State of California  
Department of Fish and Wildlife

Subject: **REVISED Flood Prone Area Assessment of the "Little" Timber Harvesting Plan (1-18-095 MEN), Mendocino County, California**

TITLE: Little North Fork Gualala River Valley Floor Geomorphology Sheet 2 of 2  
DATE: Revised November 11, 2019 SCALE: As shown

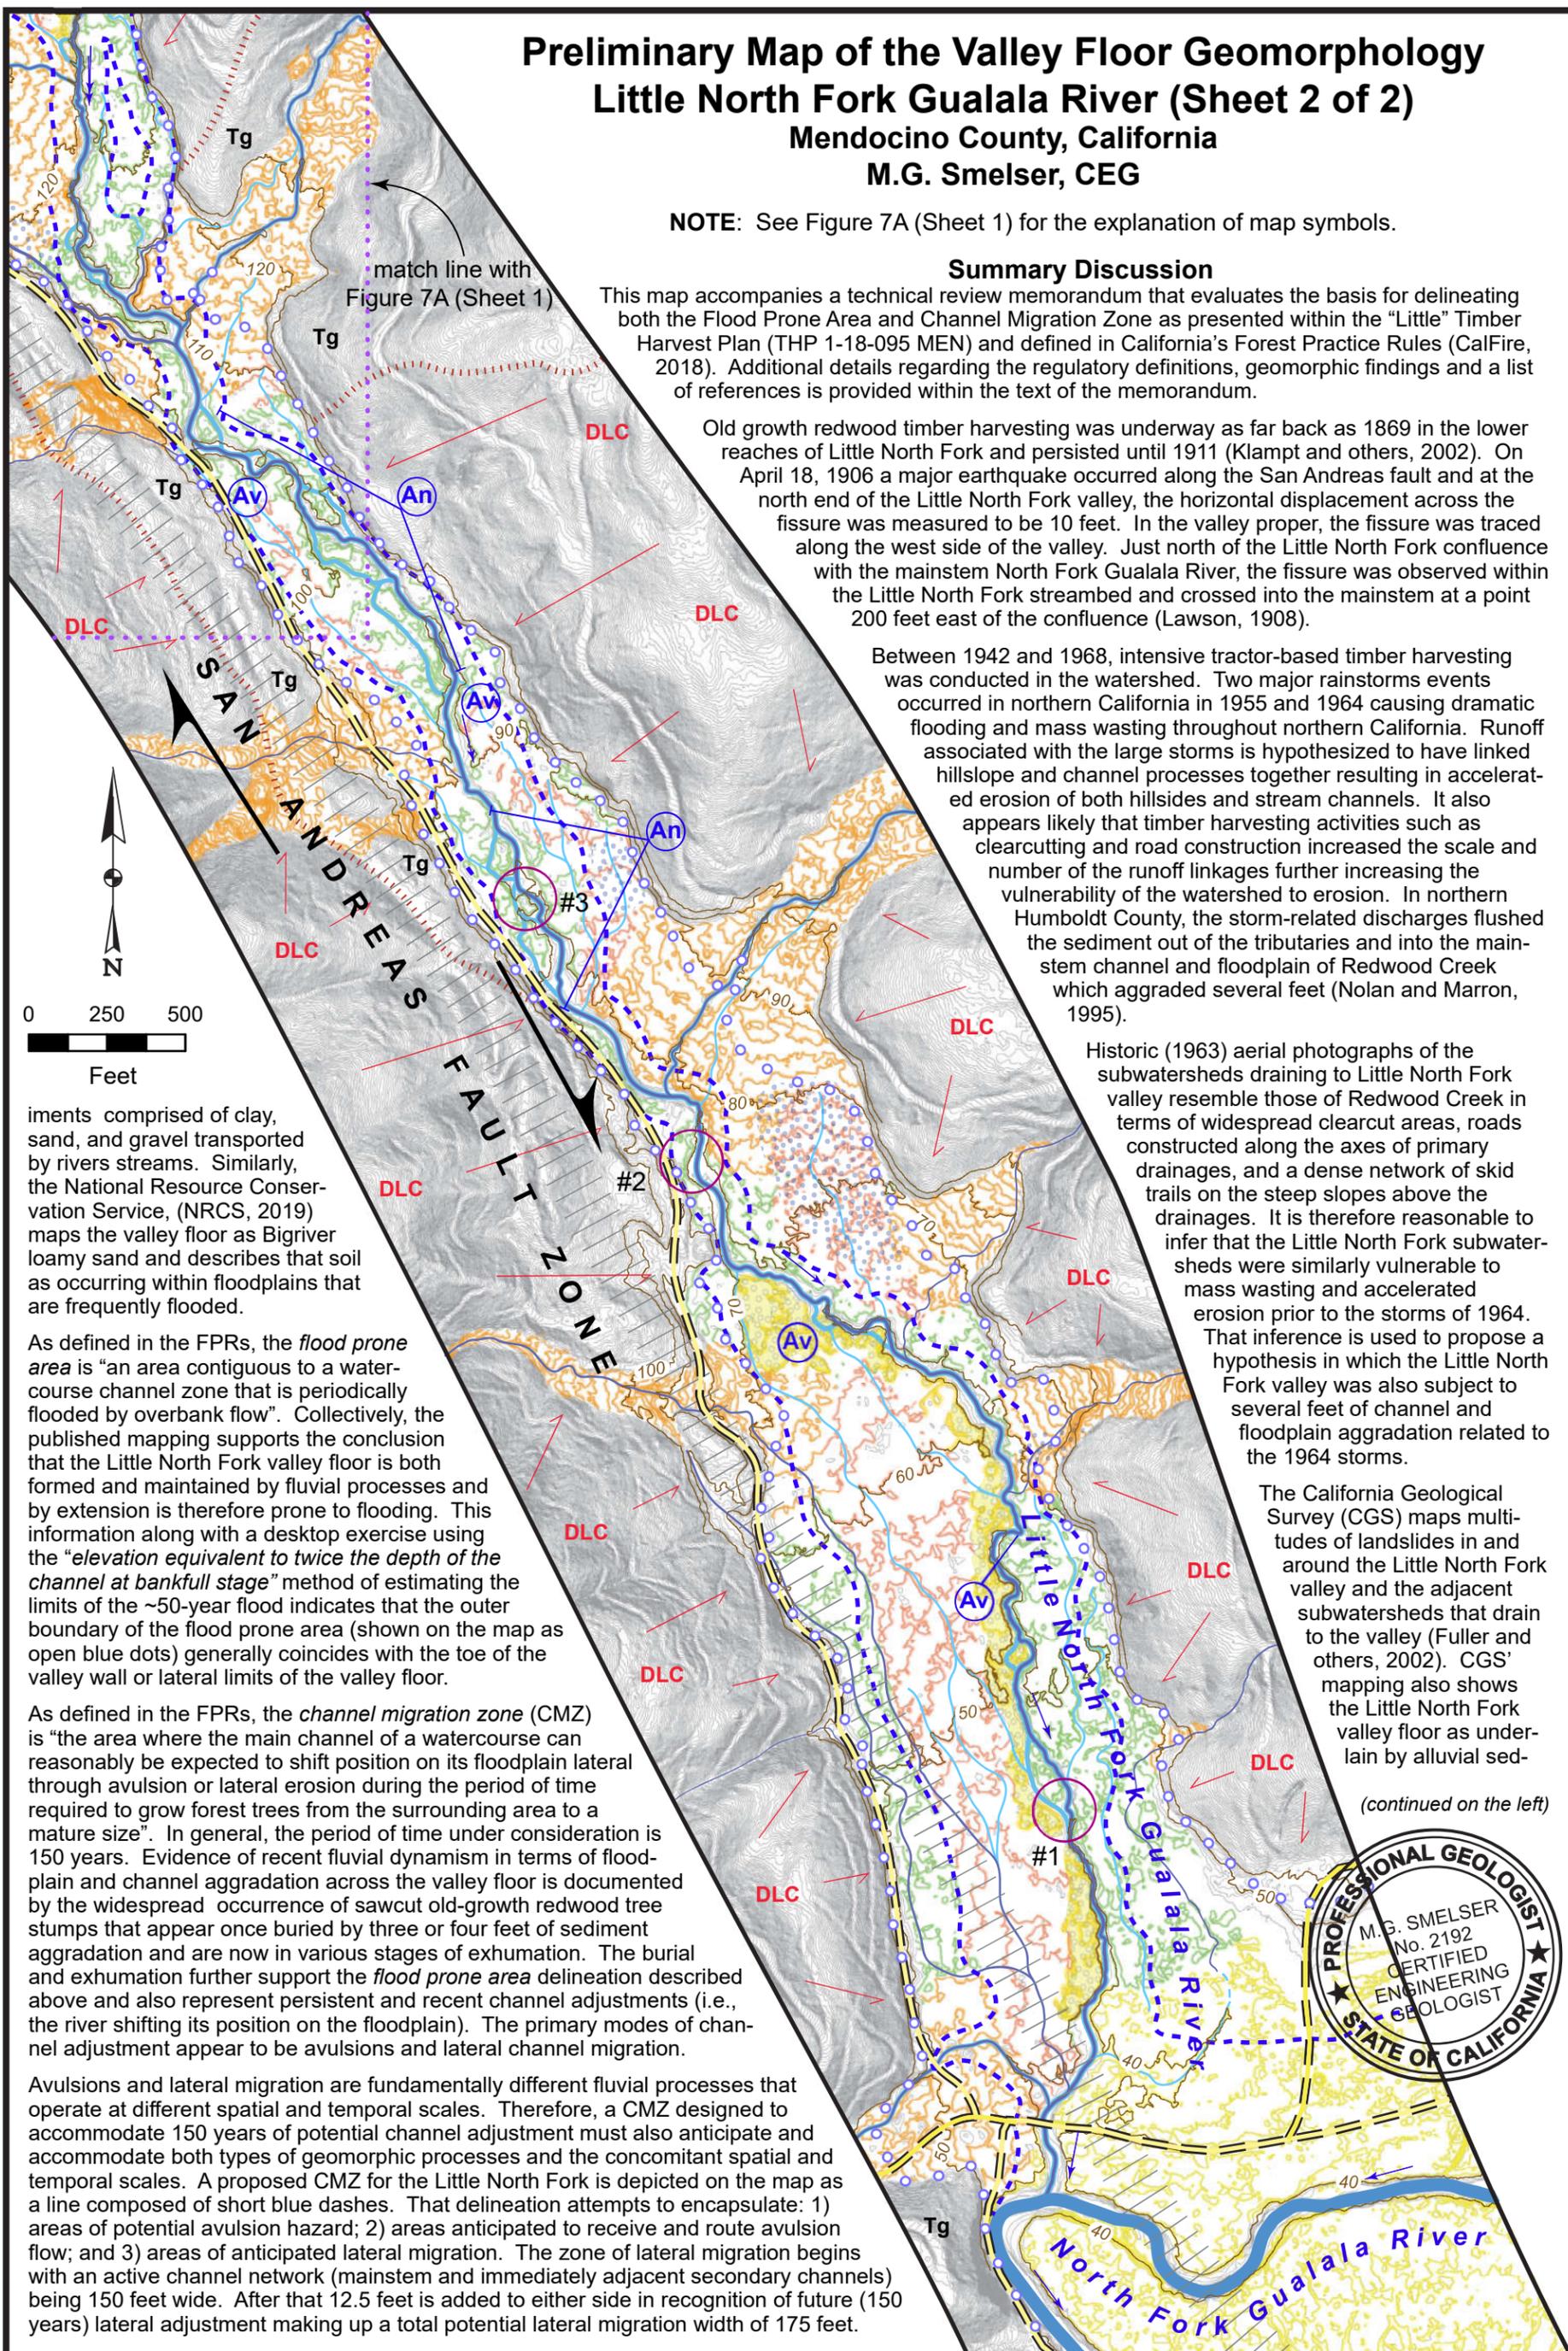
Between the tributary fans and the active channel corridor, the valley floor contours exhibit broad patterns of shallow undulatory relief. More specifically, several areas of concave down-gradient contours indicative of topographic depressions exist along the valley floor. In several cases, these depressions are hydrologic "sinks" where surface water accumulates and forms wetland areas (Figures 7A and B). The valley floor contour lines also exhibit a pattern of narrow and sharp upstream v's that are paired with similar features on adjacent contour lines up- and downslope. These patterns are interpreted to represent the remnant, largely distributary, drainage network that is assumed to have formed as part of the depositional processes that accomplished the floodplain aggradation. The drainage paths are generally straight and form a somewhat braided stream network that is activated during higher runoff events (OEI, 2019a). These remnant channels are *secondary channels* discussed previously (Rapp and Abbe, 2003; and WFPB, 2004). As depicted on the geomorphic map, the remnant channel network and hydrologic sink areas occur across local differences in topographic relief which creates the potential for different channel avulsion scenarios.

Avulsions can occur in response to a channel-spanning obstruction or overwhelming flood flows. However, because it is not possible to predict future channel obstructions, the delineation of potential avulsion sites is focused on those portions of the channel that are relatively shallow compared to the floodplain and that exhibit evidence of recent or seasonal overbank spills. Such evidence includes natural levees and fresh sediment deposits immediately adjacent to the channel. In addition, the streambank must be erodible and the “receiving” area beyond the channel must be “down-slope” in order to perpetuate streamflow. Several such areas are visible on the geomorphic map and are designated “Av” (Figures 7A and B). Moreover, the topographic depressions associated with these designations include remnant or “secondary” channels that will facilitate an avulsion. In adopting a conservative approach, overbank spills are considered likely to occur anywhere along a vulnerable streambank and then drain in and out of the receiving topographic depression at multiple locations. Consequently, delineating avulsion type CMZs necessarily must include the entirety of the vulnerable bank and that of the potential receiving area (topographic depression) as well.

suggested by the longitudinal profile (Figure 8), the stream appears well on its way toward achieving dynamic equilibrium in terms of vertical downcutting which suggests that future channel adjustments will likely be focused in a horizontal direction via lateral erosion. While much of the Little North Fork is a single-thread channel that is approximately 60 feet wide, it also includes numerous secondary channels that weave in and out and around the main channel. In adopting a conservative approach, the various secondary channels combined with the primary active channel are interpreted to represent the contemporary scale of active lateral migration currently underway and defines an active CMZ of approximately 150 feet in width. In anticipation of 150 years of future channel migration and a conservative approach, a nominal value of one inch per year of lateral erosion is assumed. This equates to 12.5 feet over that period of time. Adding 12.5 feet to either side of the contemporary CMZ equates to a proposed lateral migration CMZ width of 175 feet. The combined avulsion and lateral migration CMZ is delineated on the geomorphic map with heavy dashed dark blue line (Figures 7A and B).

As defined in the FPRs, the *flood prone area* is "an area contiguous to a watercourse channel zone that is periodically flooded by overbank flow". Collectively, the published mapping supports the conclusion that the Little North Fork valley floor is both formed and maintained by fluvial processes and by extension is therefore prone to flooding. This information along with a desktop exercise using the "elevation equivalent to twice the depth of the channel at bankfull stage" method of estimating the limits of the ~50-year flood indicates that the outer boundary of the flood prone area (shown on the map as open blue dots) generally coincides with the toe of the valley wall or lateral limits of the valley floor.

As defined in the FPRs, the *channel migration zone* (CMZ) is "the area where the main channel of a watercourse can reasonably be expected to shift position on its floodplain lateral through avulsion or lateral erosion during the period of time required to grow forest trees from the surrounding area to a mature size". In general, the period of time under consideration is 150 years. Evidence of recent fluvial dynamism in terms of floodplain and channel aggradation across the valley floor is documented by the widespread occurrence of sawcut old-growth redwood tree stumps that appear once buried by three or four feet of sediment aggradation and are now in various stages of exhumation. The burial and exhumation further support the *flood prone area* delineation described above and also represent persistent and recent channel adjustments (i.e., the river shifting its position on the floodplain). The primary modes of channel adjustment appear to be avulsions and lateral channel migration.

Avulsions and lateral migration are fundamentally different fluvial processes that operate at different spatial and temporal scales. Therefore, a CMZ designed to accommodate 150 years of potential channel adjustment must also anticipate and accommodate both types of geomorphic processes and the concomitant spatial and temporal scales. A proposed CMZ for the Little North Fork is depicted on the map as a line composed of short blue dashes. That delineation attempts to encapsulate: 1) areas of potential avulsion hazard; 2) areas anticipated to receive and route avulsion flow; and 3) areas of anticipated lateral migration. The zone of lateral migration begins with an active channel network (mainstem and immediately adjacent secondary channels) being 150 feet wide. After that 12.5 feet is added to either side in recognition of future (150 years) lateral adjustment making up a total potential lateral migration width of 175 feet.

**FIGURE:** 8

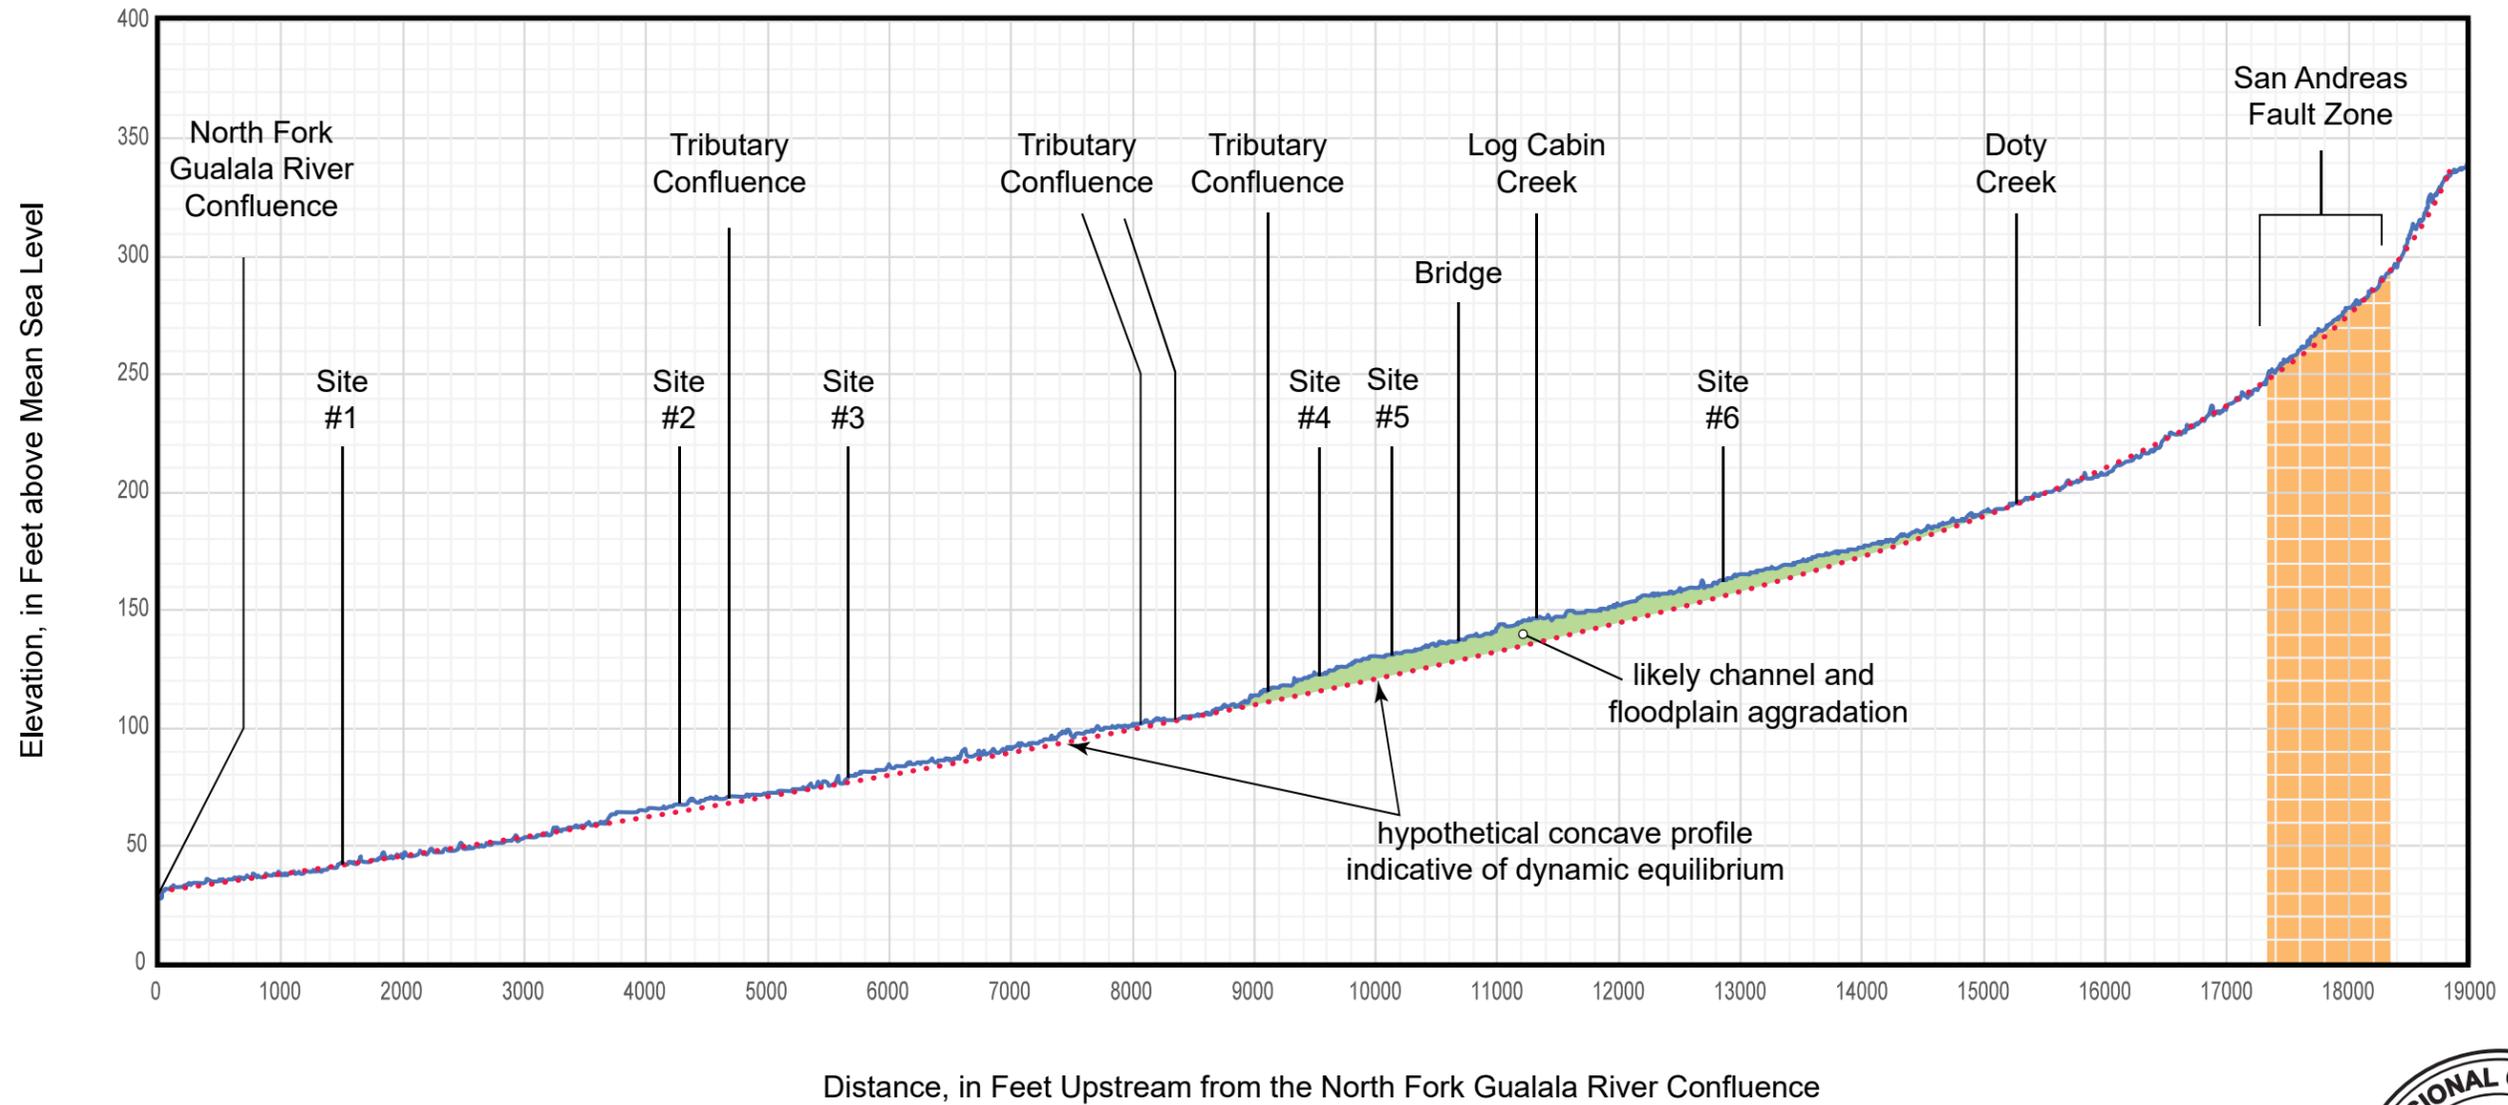
Little North Fork follows a somewhat tortuous path as it flows through the aggraded floodplain containing buried tree stumps, impinges upon valley walls, and is locally constrained by numerous alluvial fans. The longitudinal profile (Figure 8) of Little North Fork derived from the LiDAR data exhibits generally smooth concavity which is suggestive of a well-graded alluvial stream in dynamic equilibrium (Mackin, 1948). However, a recognizable topographic bulge underlies approximately one mile of stream segment between Doty Creek at the upstream end and opposing tributary fans deposits downstream of Site #4 (Figures 7A and 8). This provides additional context for both the widespread channel and floodplain aggradation as well as the stream's success in downcutting and reworking the floodplain sediment. While the contemporary Little North Fork thalweg appears to be evolving toward dynamic equilibrium, longitudinal profiles of the major tributaries do not appear similarly at grade with the Little North Fork. Such a situation is consistent with a recent period of substantial sediment deposition and creates a potential for accelerated erosion (headcutting) up through the tributary channels and concomitant sediment delivery to the Little North Fork as the tributaries work to achieve a graded condition with the mainstem.
